HISTORIC AND DESIGN REVIEW COMMISSION

Agenda Item No: 15

HDRC CASE NO: 2016-376
ADDRESS: 1447 W LYNWOOD
LEGAL DESCRIPTION: NCB 2763 BLK 68 LOT 13
ZONING: R4 H
CITY COUNCIL DIST.: 1
DISTRICT: Keystone Park Historic District
APPLICANT: Humberto Perez
OWNER: Humberto Perez
TYPE OF WORK: New construction of an accessory structure
REQUEST:

The applicant is requesting a Certificate of Appropriateness for approval to construct a rear detached garage on an existing concrete slab.

Site Plan

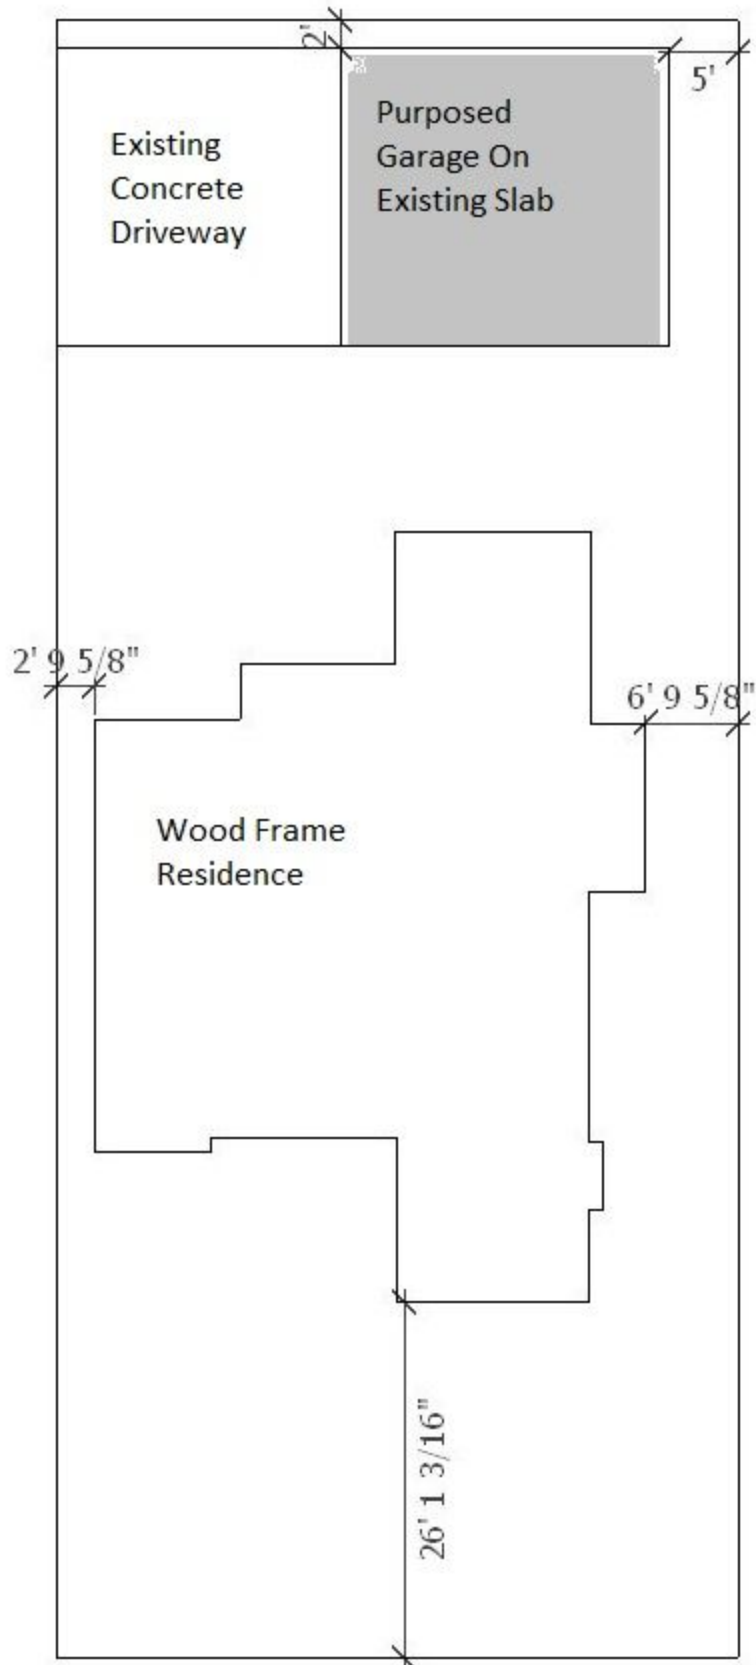
- e. **SETBACKS/ORIENTATION** - The applicant is proposing to construct a garage on an existing concrete driveway, oriented toward Buckeye Avenue with 2’ rear property line setback, and a 5’ right property line setback. According to the Guidelines for New Construction 5.B, new outbuildings match predominant garage and carport orientations. Staff made a site visit on September 12, 2016, and found that homes on corner lots in the Keystone Historic District historically had garages facing the side street and set in the rear. Staff finds the proposed setback and orientation consistent with the Guidelines.

The applicant is responsible for meeting setback requirements set by the UDC.

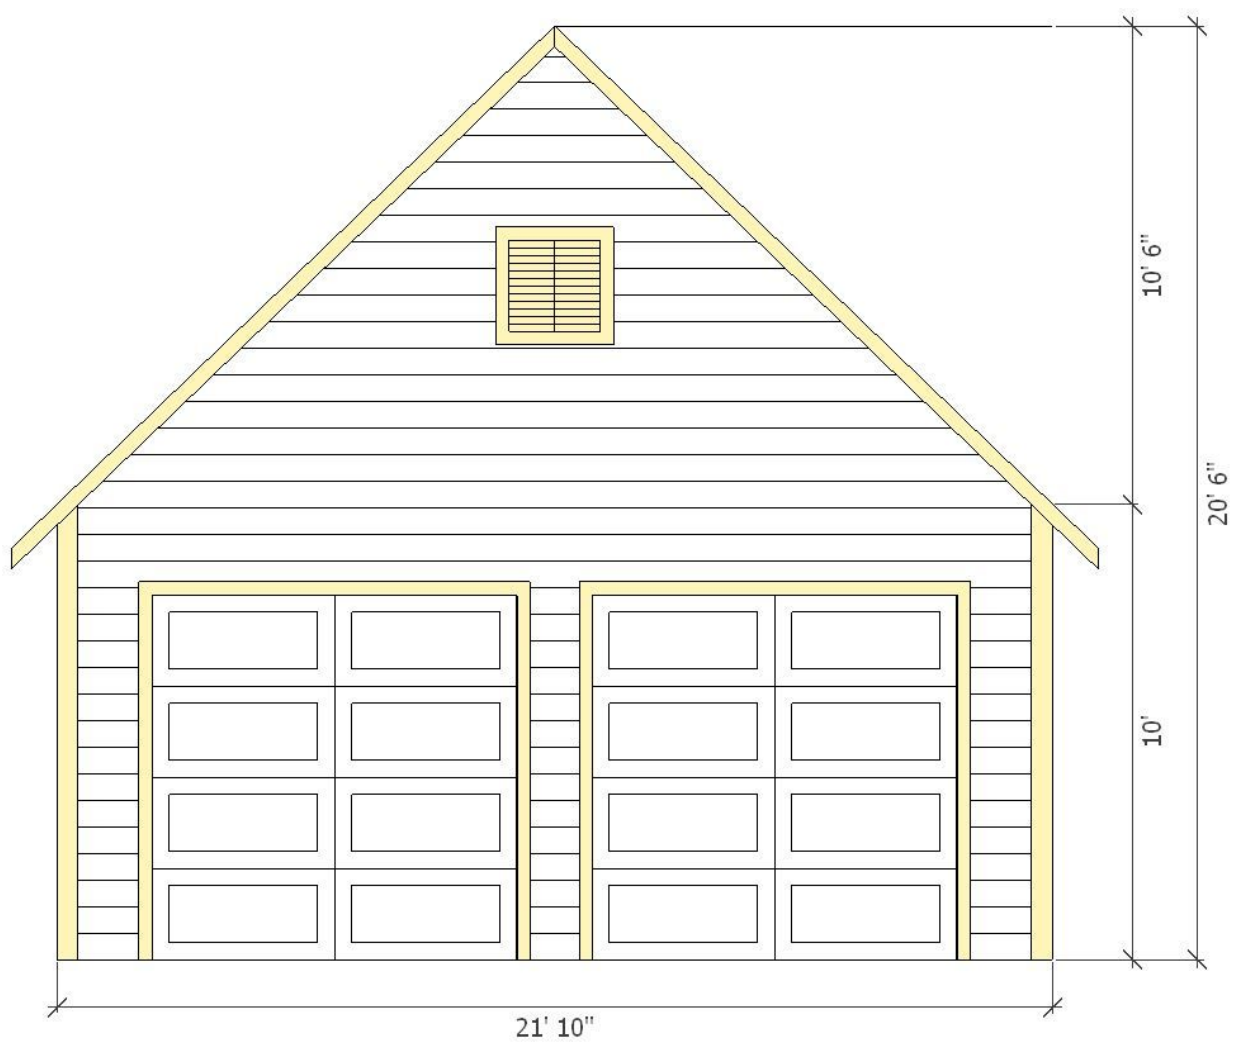
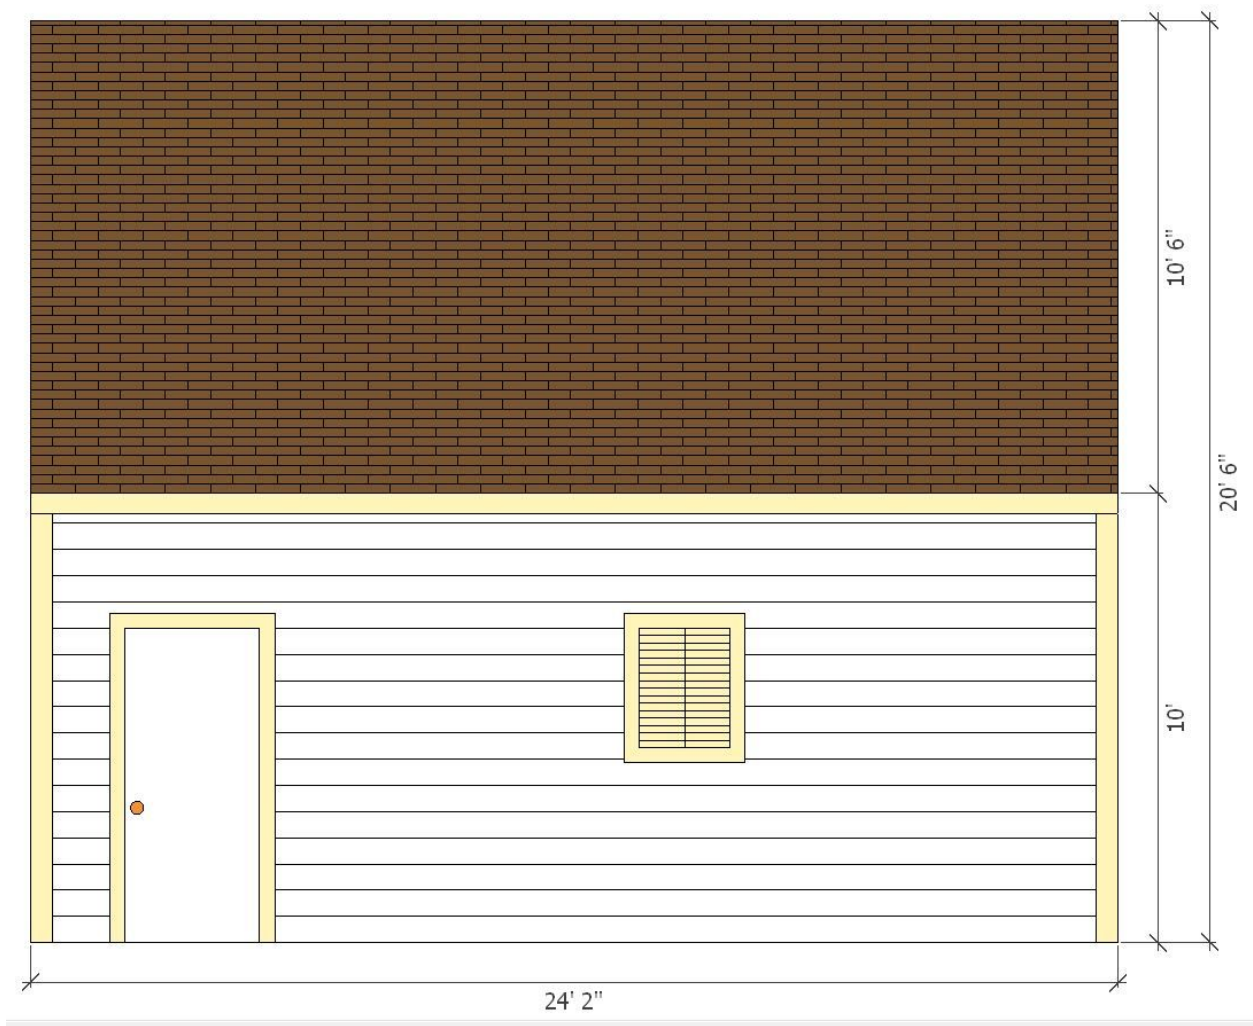
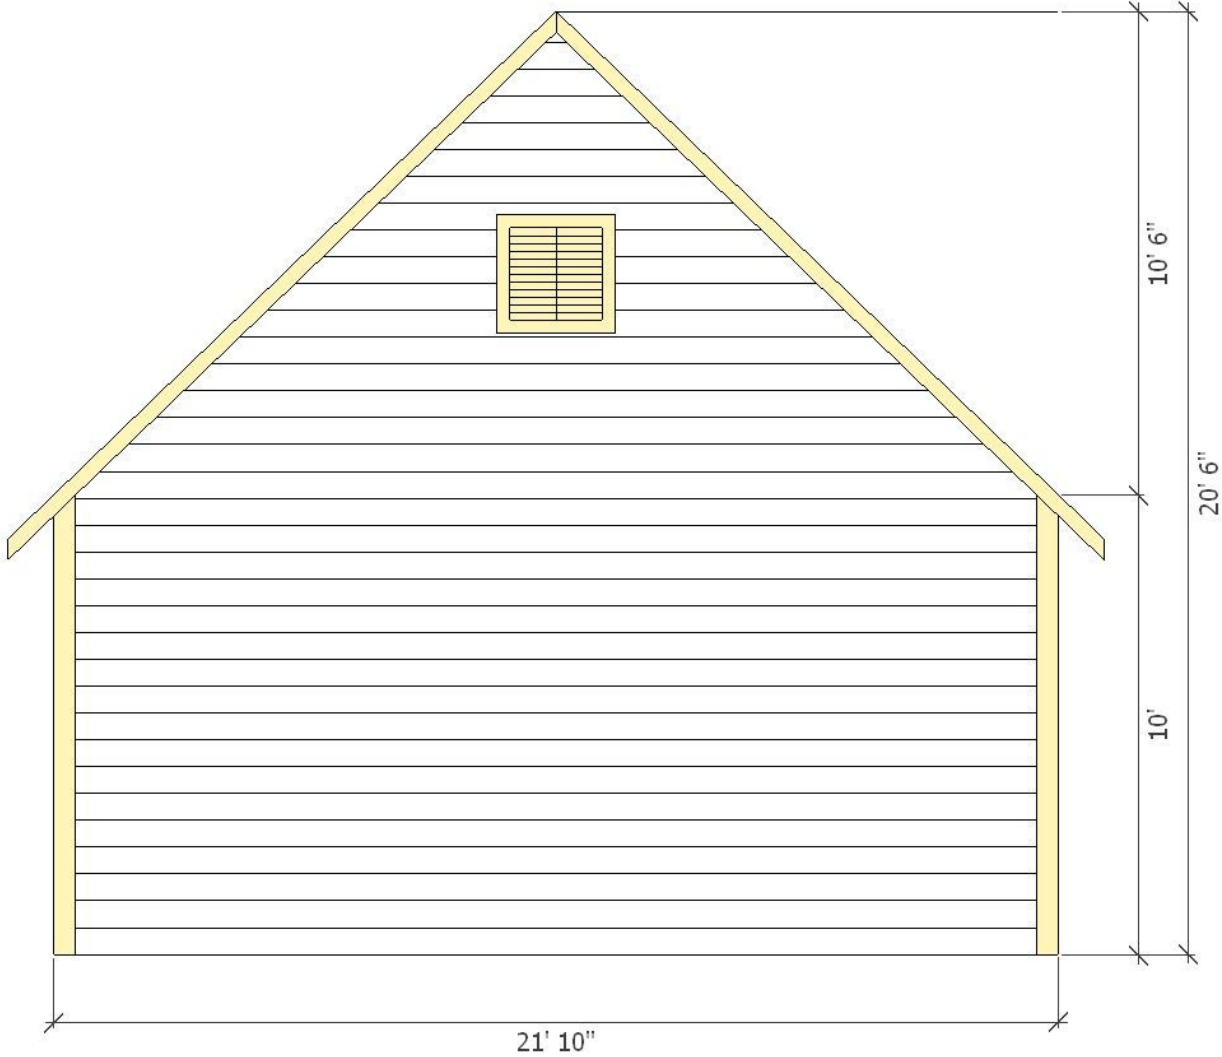
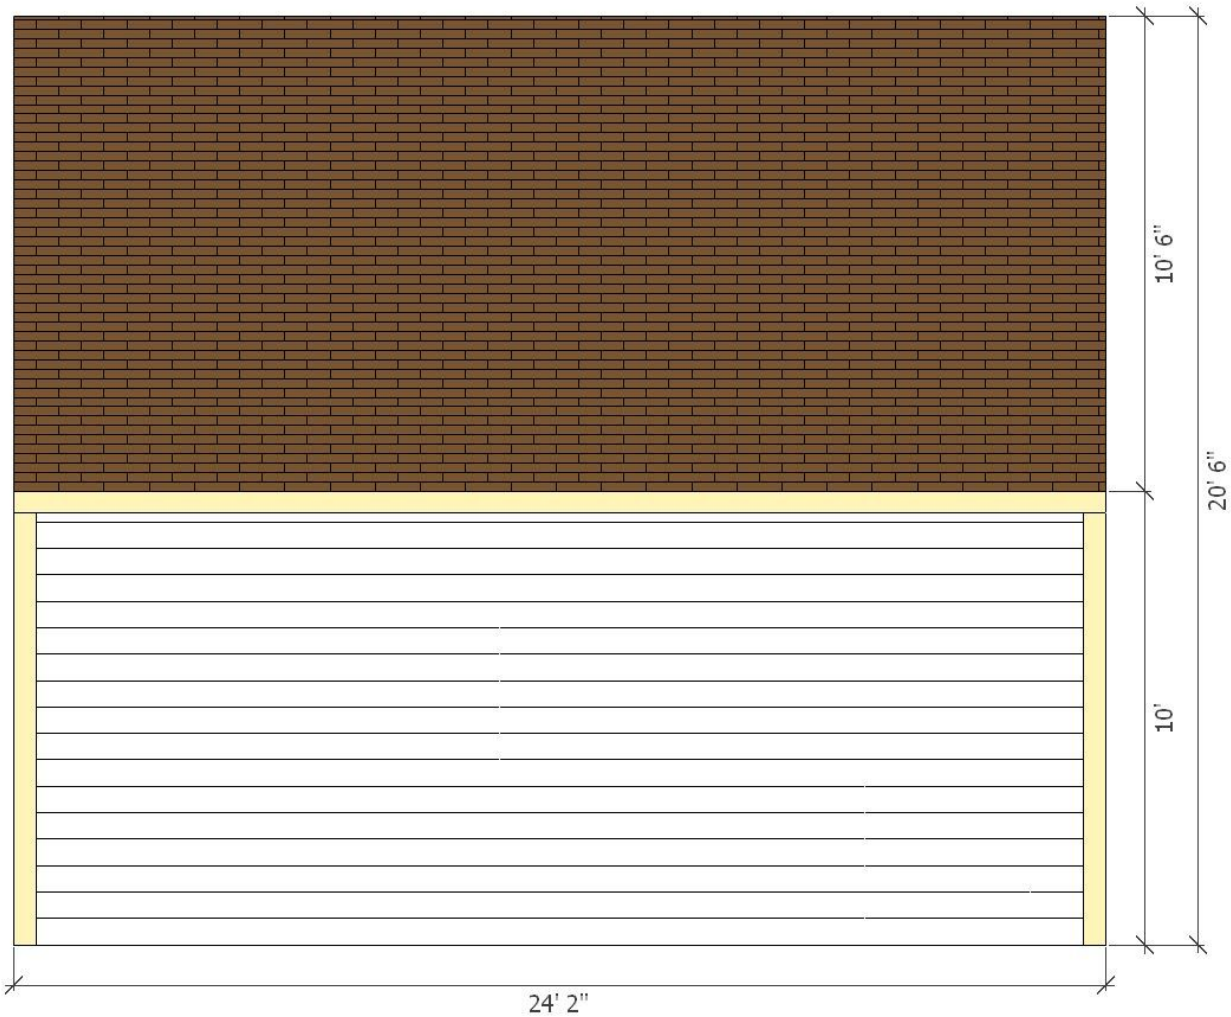
- c. **MASSING/FORM** - The applicant is proposing to construct a rear garage that is 21'-10" wide, 24'-2" deep, and 20'-6" tall. According to the Guidelines for New Construction 5.A., new outbuildings should be no larger in plan than 40% of the principal historic structure's foot print, and should be visibly subordinate to historic structures.

Staff made a site visit September 12, 2016, and found that the proposed garage would be obstructed from view from the public right-of-way by a privacy fence and to the interior corner of the lot. Staff finds the proposed form consistent with the Guidelines, but recommends the applicant submit details showing that the proposed ridge height is below that of the main structure.

- 1. That the proposed ridge height is below that of the main structure.
- 2. That the garage doors be carriage style and details of the new doors be submitted to staff prior to receiving a Certificate of Appropriateness.
